November 14, 2022

Re: U.S. Department of Energy Clean Hydrogen Production Standard (CHPS)  
Draft Guidance

Figure 1: A lifecycle system boundary enables consistent and comprehensive evaluation of diverse hydrogen production systems. Examples of key emission sources within each step typically considered in the boundary are shown above.<sup>11</sup>

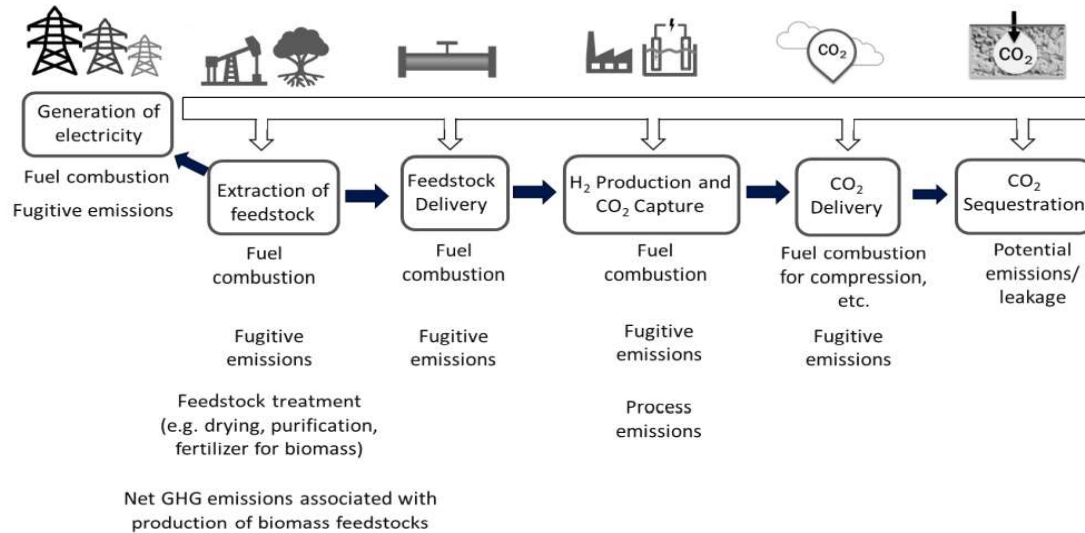
*Response:* Figure 1 (copied below) appears to include the major steps associated with a lifecycle analysis of hydrogen production. The phrasing “extraction of feedstock” seems a little targeted to fossil fuel sources. We would suggest clarifying where organic waste biomass feedstocks would fall. In particular, we recommend that the reference to “Net GHG emissions associated with production of biomass feedstocks” should be clarified to ensure that this step includes both avoided emissions benefits from organic waste to RNG for all GHGs (e.g., methane) as well as sinks of CO<sub>2</sub> as biogenic material (that eventually becomes the organic waste) is grown.
